Sundt Construction
125 E John Carpenter Fwy
Unit 1600
Irving, TX 75062

17 February 2026

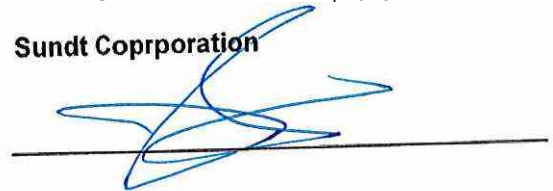
#1-4	Sawcut and Remove Concrete Flatwork	340.00	SF	\$	2.65	\$	901.00
#1-18	6-Inch Lime Stabilized Subgrade	37.78	SY	\$	8.60	\$	324.91
#1-21	10-Inch Reinforced Concrete Pavement Including 6-Inch Curb	37.78	SY	\$	115.00	\$	4,344.70
#1-22	Concrete Header	68.00	LF	\$	82.00	\$	5,576.00
#1-2	Temporary Traffic Control	1.00	LS	\$	2,815.96	\$	2,815.96
	Insurance and Bond-1.5%	1.00	LS	\$	209.44	\$	209.44
	15% Mark Up	1.00	LS	\$	2,125.80	\$	2,125.80
	Subtotal					\$	16,297.81
	Deductions						
#1-71	2-Inch RM Conduit on Bridge	(1,723.00)	LF	\$	71.22	\$	(122,712.06)
#1-85	Electrical Service for Irrigation	(1.00)	EA	\$	9,085.94	\$	(9,085.94)
#1-78	Street Light Ground Box	(1.00)	EA	\$	1,257.58	\$	(1,257.58)
	Subtotal					\$	(133,055.58)
	Total					\$	(1,393,226.43)
Total Amount of Change Order No. <u>06</u>						\$	(1,393,226.43)

That upon approval of Change Order No. 06 by the _____ of the City of Lewisville, the City will give notice of such approval to the Contractor within ten (10) calendar days.

CHANGE ORDER No. 06 APPROVED BY _____ THIS _____ DAY OF _____, 2026.

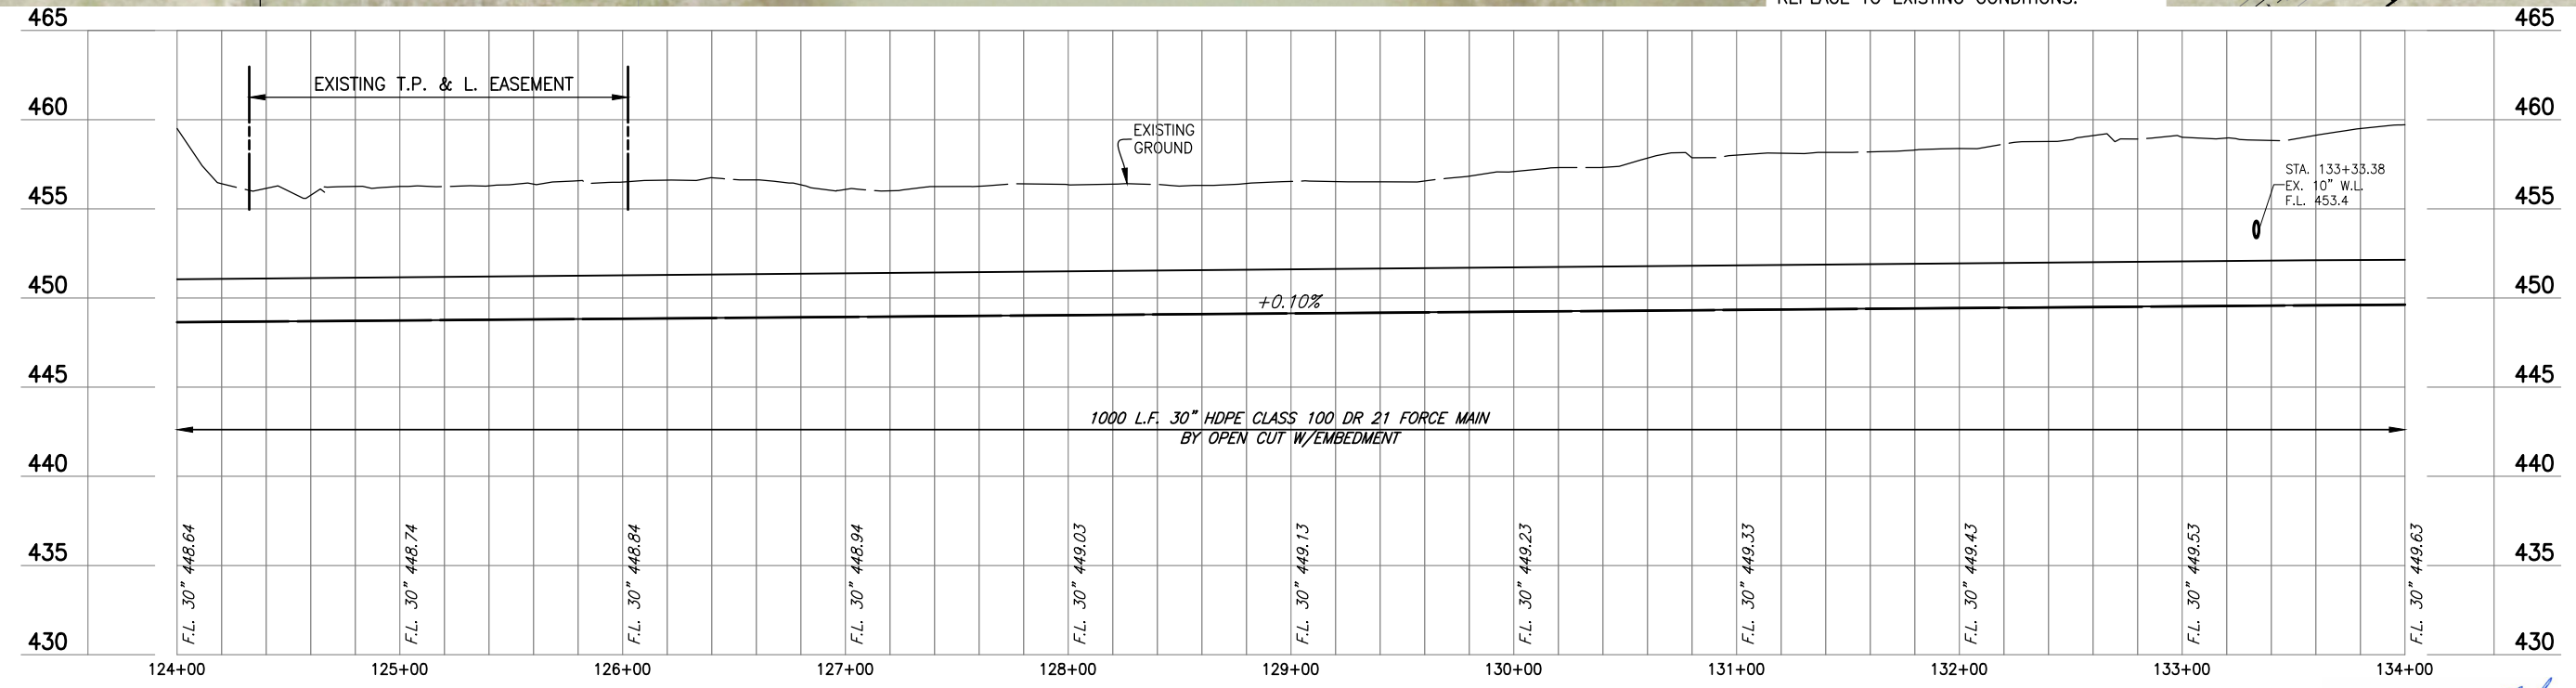
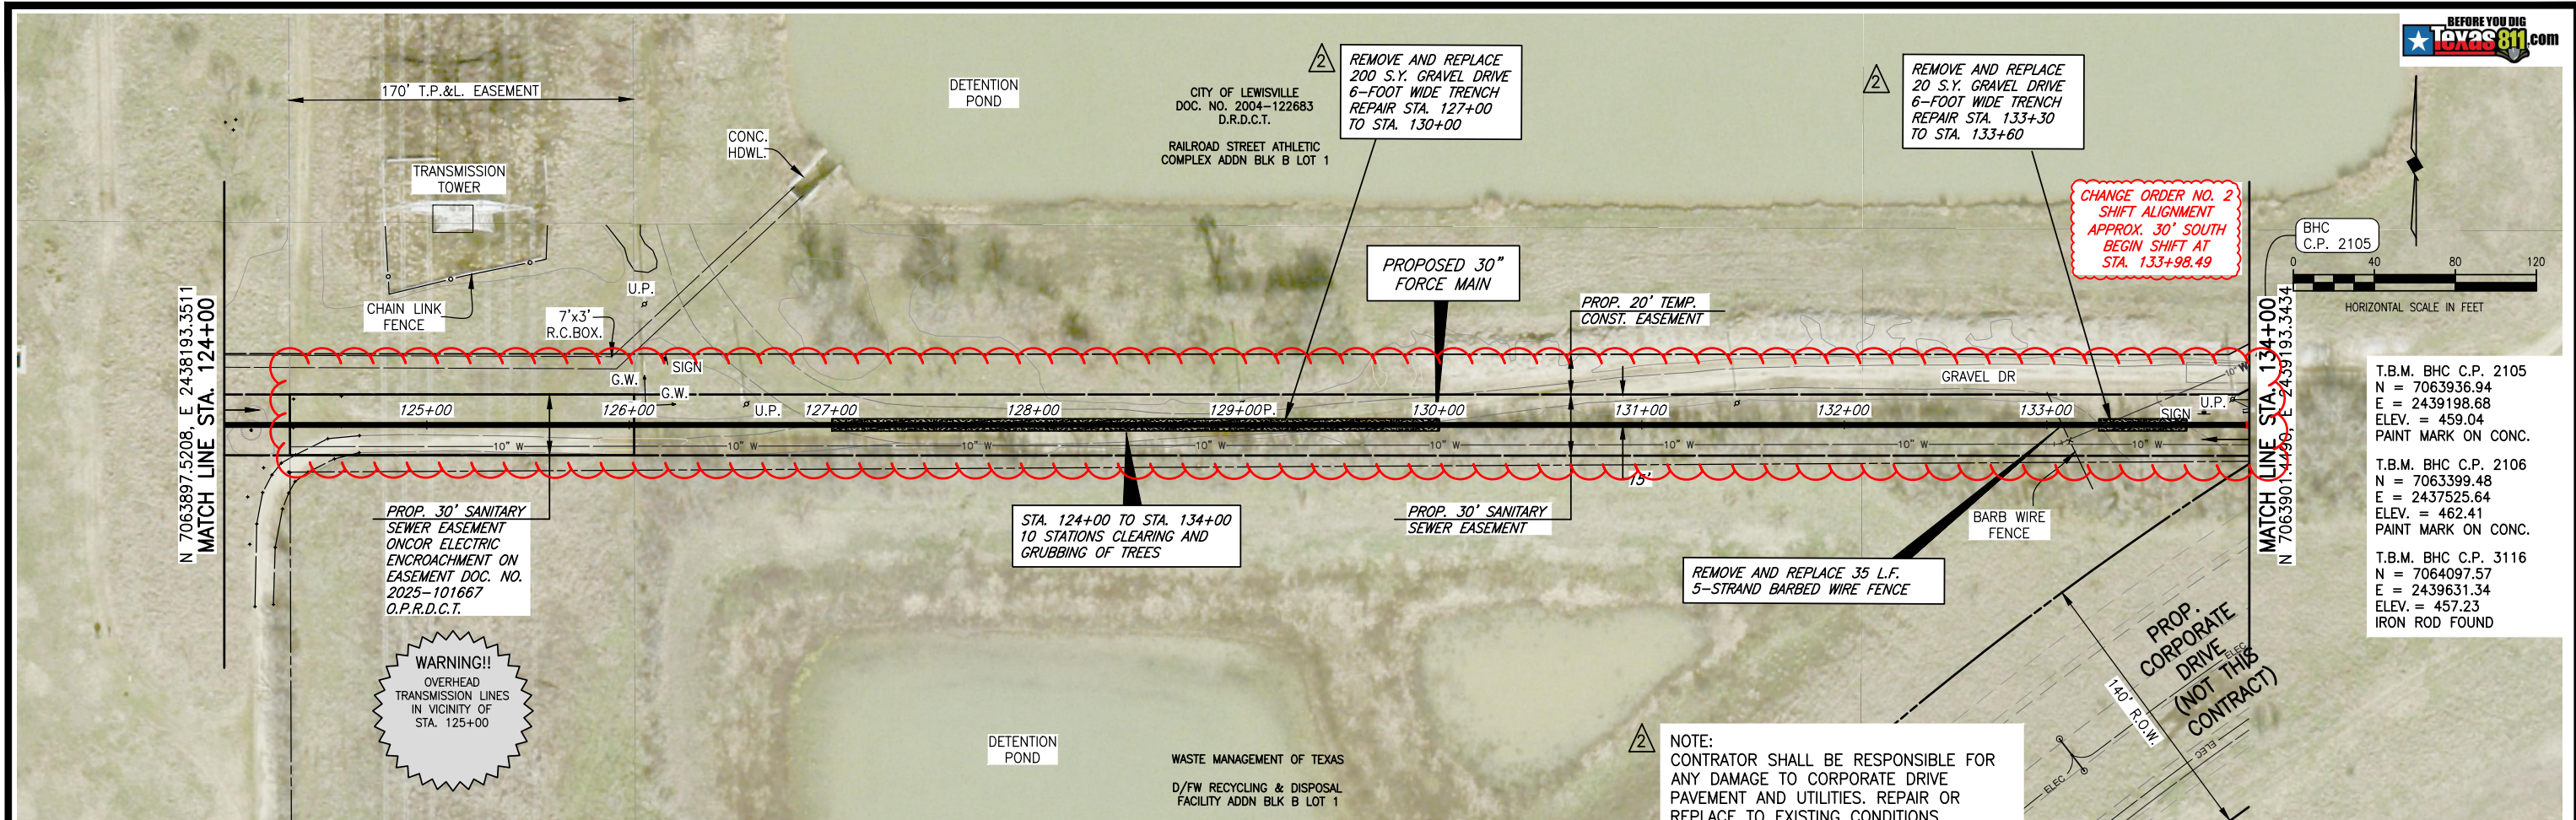
ADDENDUM NO. 2

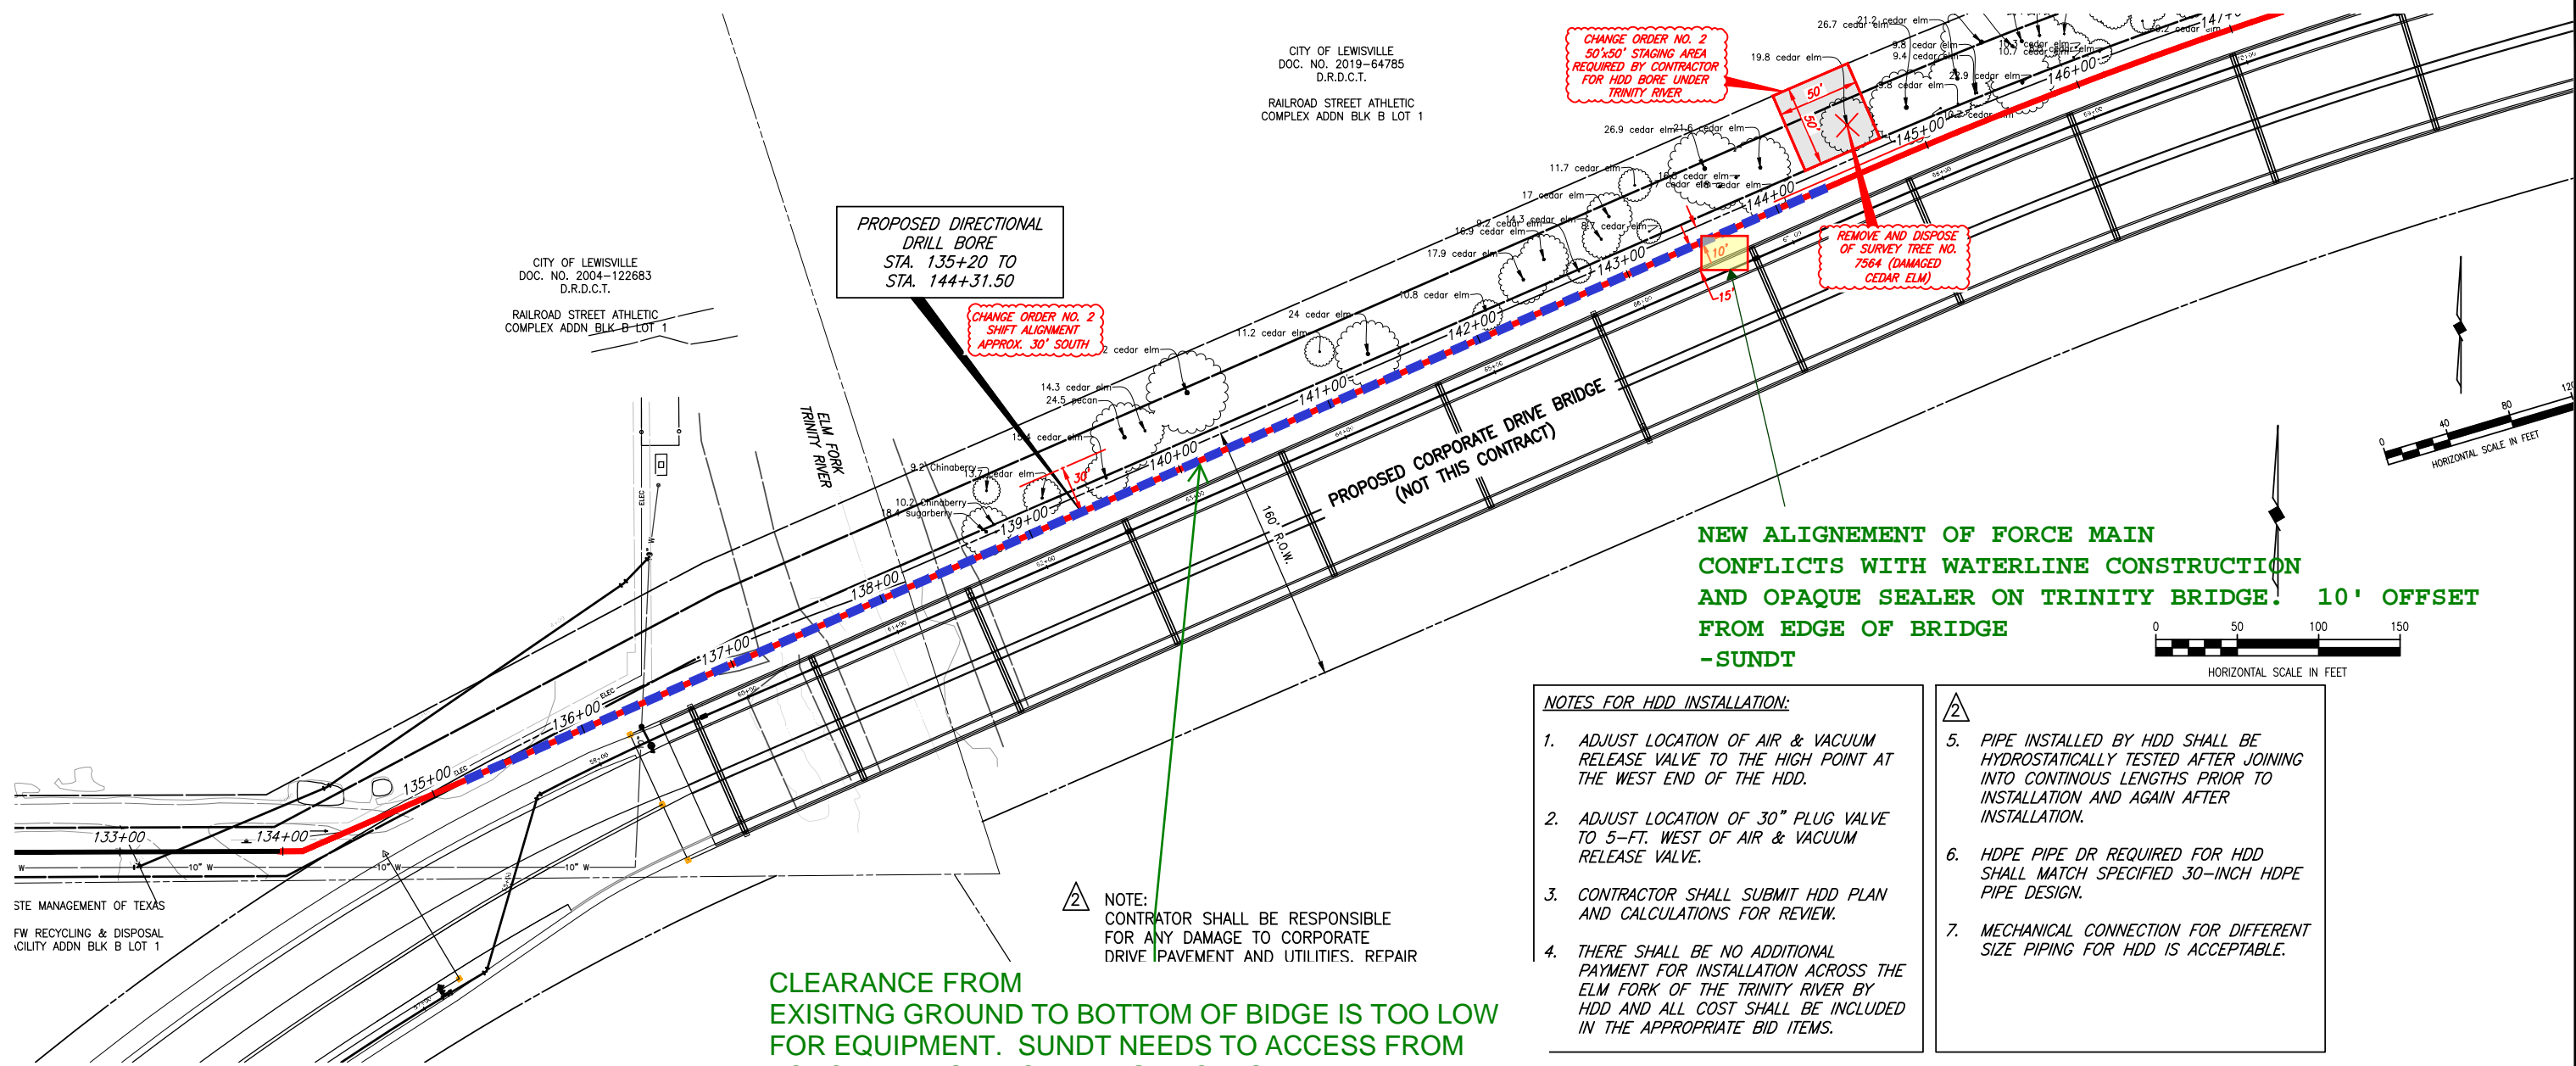
CHANGE ORDER NO. 2
 SHIFT ALIGNMENT
 APPROX. 30' SOUTH

CHANGE ORDER NO. 2
 50'x50' STAGING AREA
 REQUIRED BY CONTRACTOR
 FOR HDD BORE UNDER
 TRINITY RIVER

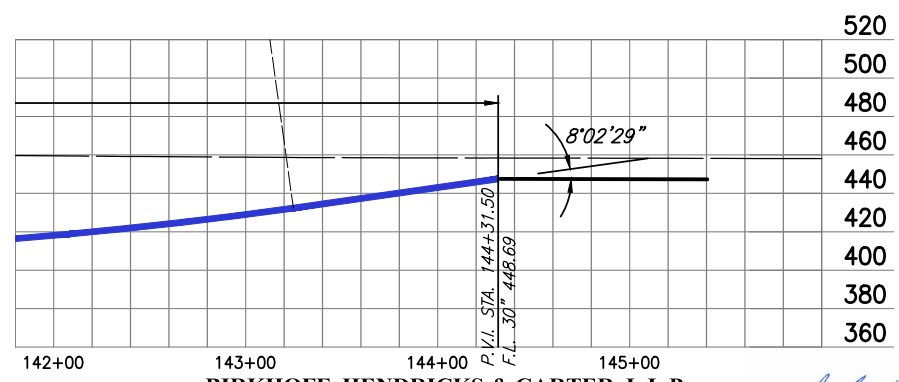
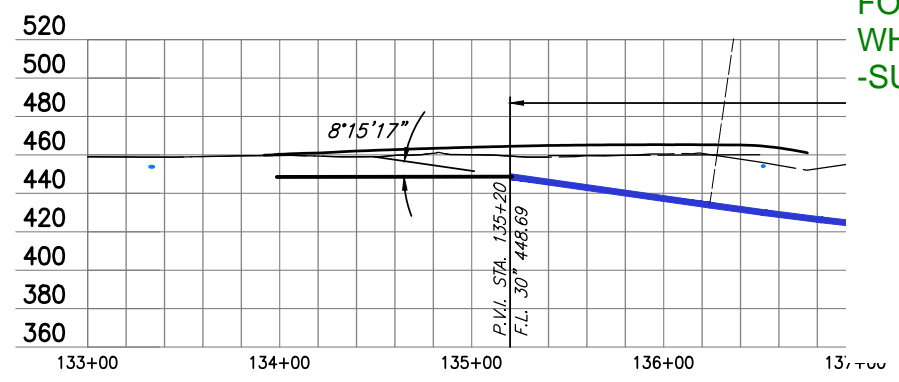
ADDENDUM NO. 2

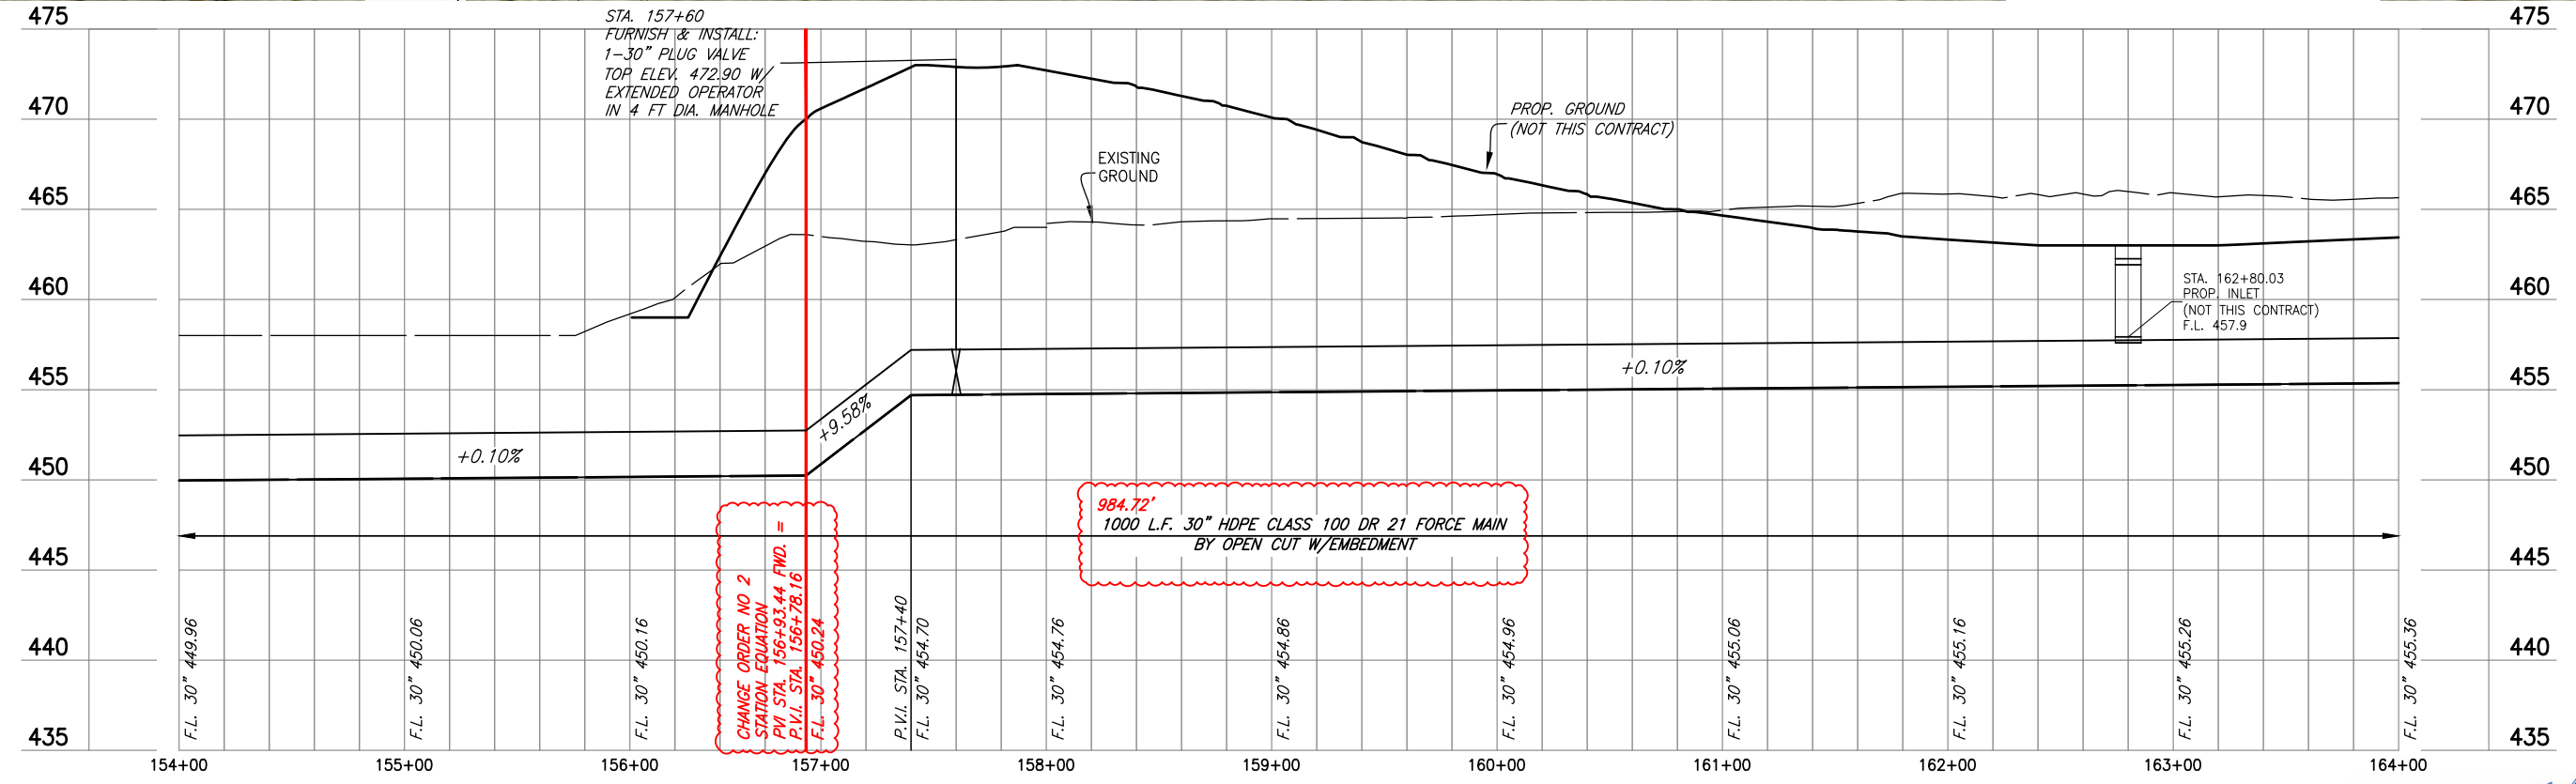
ADDENDUM NO. 2
